Response to Neighbor Concerns

Prepared by Deepak Gupta and team, on June 26-28, 2026

Submitted to Town of Los Gatos on June 29, 2026

Figure B12

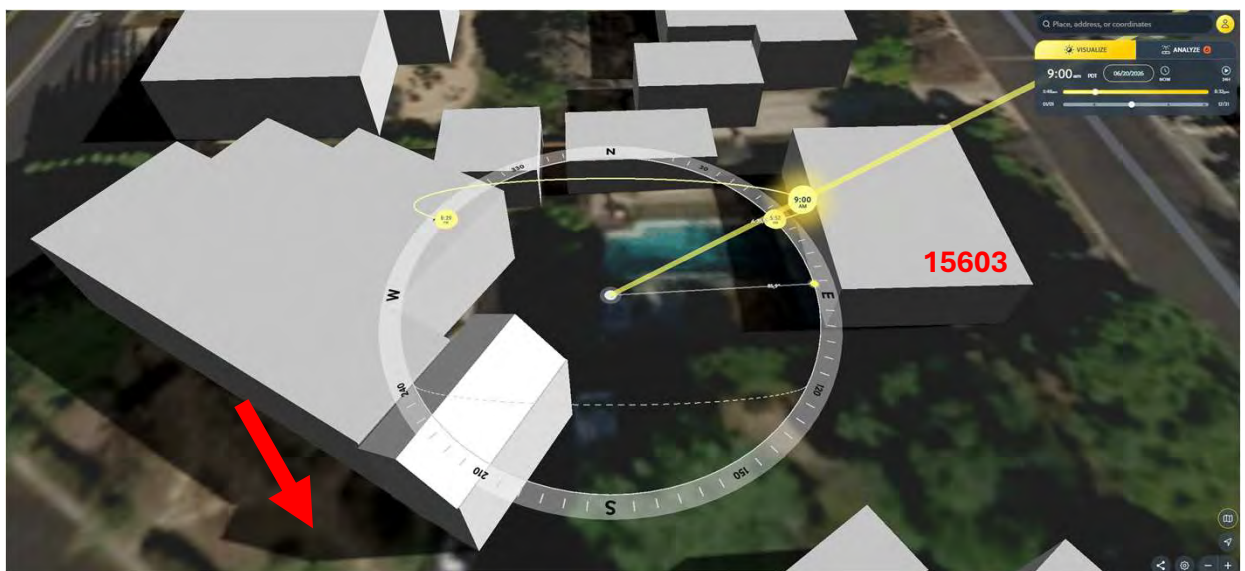
The **proposed second story** casts a shadow to the west and has no impact on the neighbor.

Figure B13

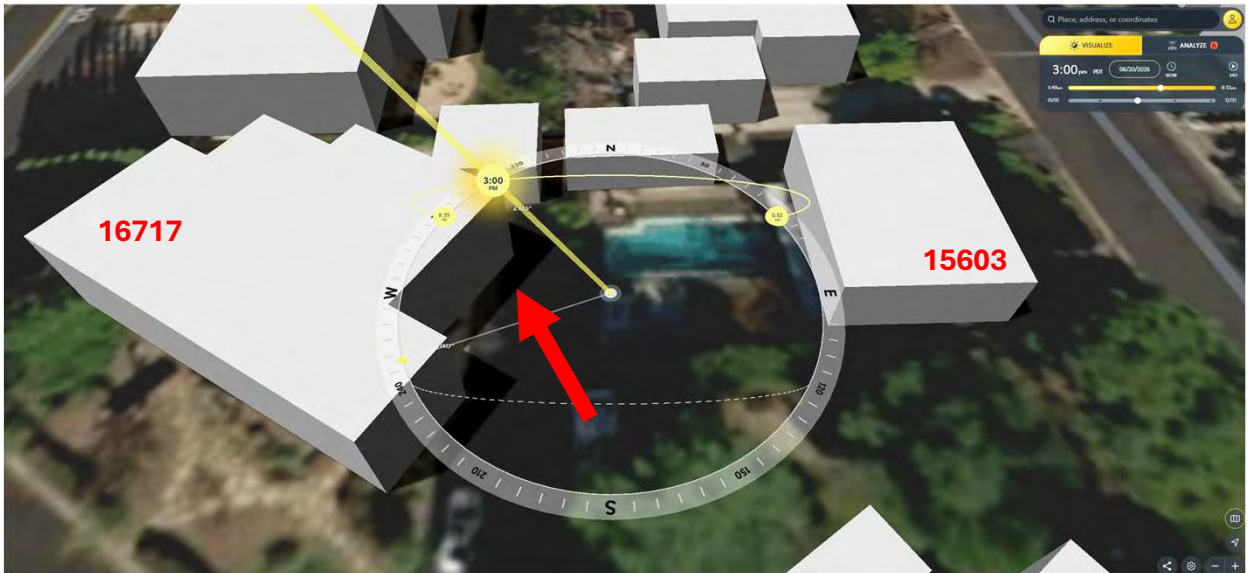
Our **existing** home casts a short shadow and has no impact on the neighbor.

Figure B14

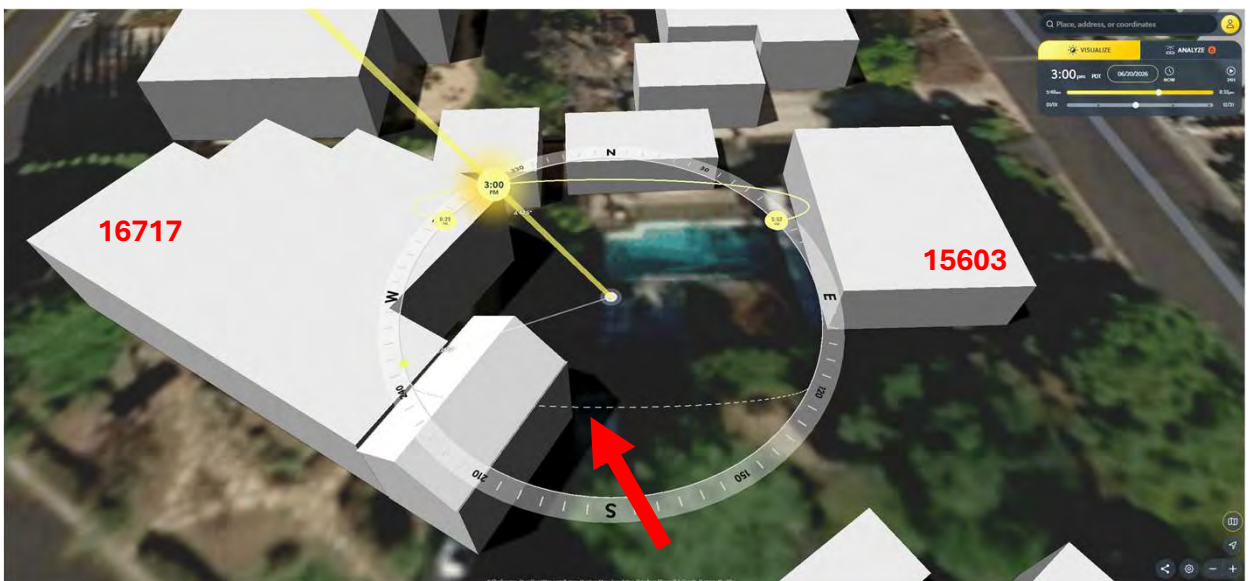
The **proposed second story** casts a short shadow and has no impact on the neighbor.

Figure
B15

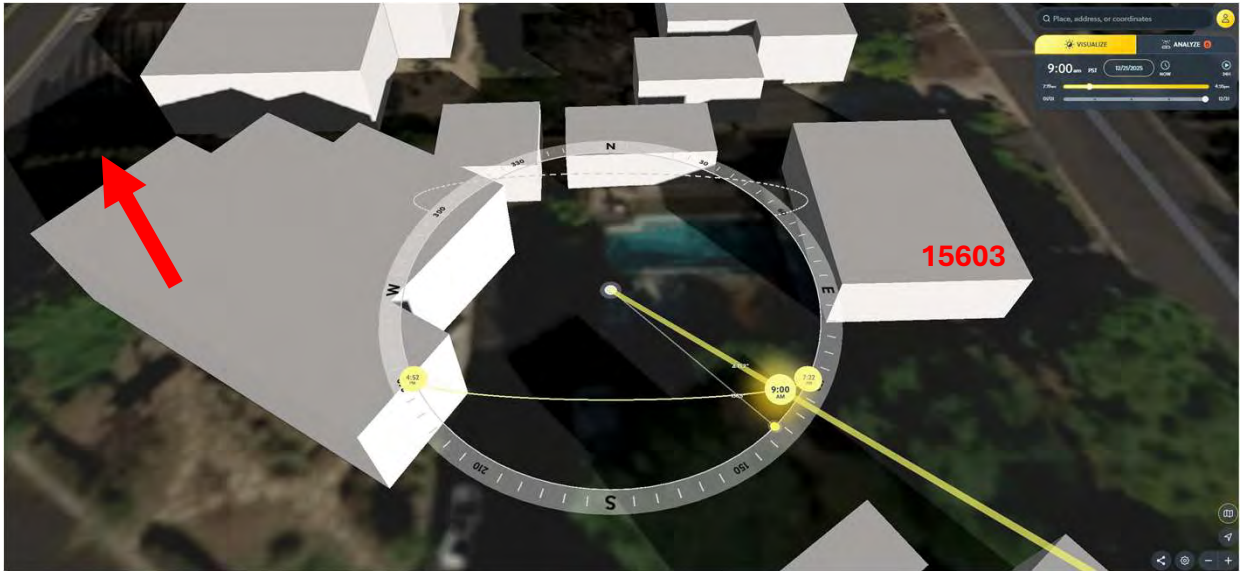
Our **existing** home casts a shadow to the northwest and has no impact on the neighbor.

Figure
B16

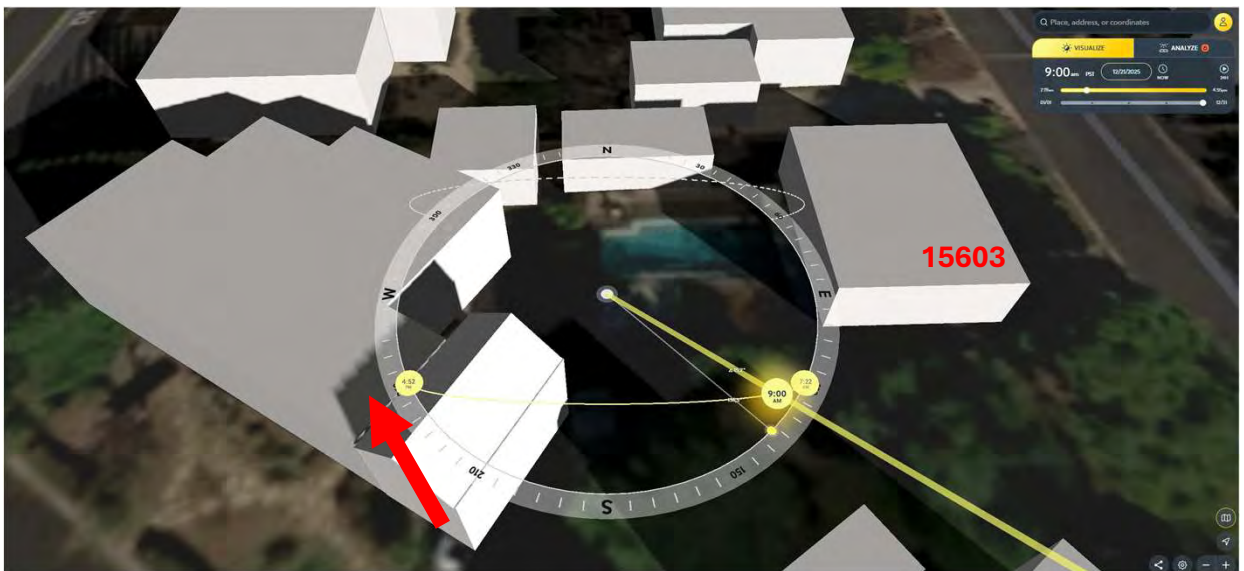
The **proposed second story** casts a shadow to the northwest and has no impact on the neighbor.
